TECHNICAL SERVICE BULLETIN

Oil Filter Bypass Valve Must be Updated

APPLICATION INFORMATION: ALL ISM, QSM, ISX, QSX ENGINES

TSB160017 New Oil Bypass Valve
4908439 Installation Instructions

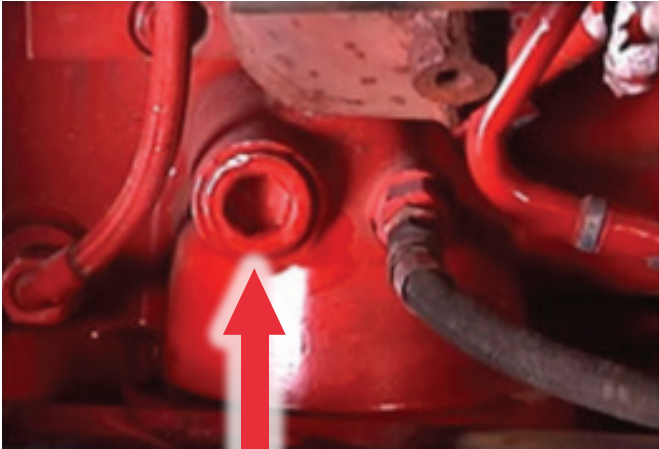
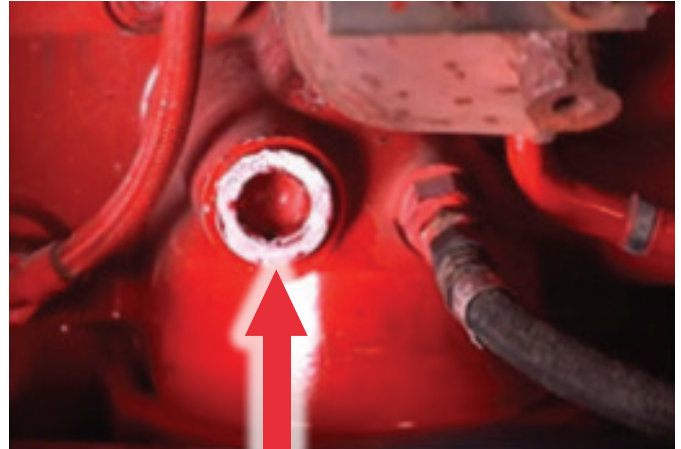
NEEDS UPDATE PERFORMED

NO PAINT:
needs update performed.

UPDATED

PAINT:
revised bypass has been installed.

Failure to update the bypass will allow unfiltered oil into the turbocharger bearings and cause it to fail, voiding the warranty.
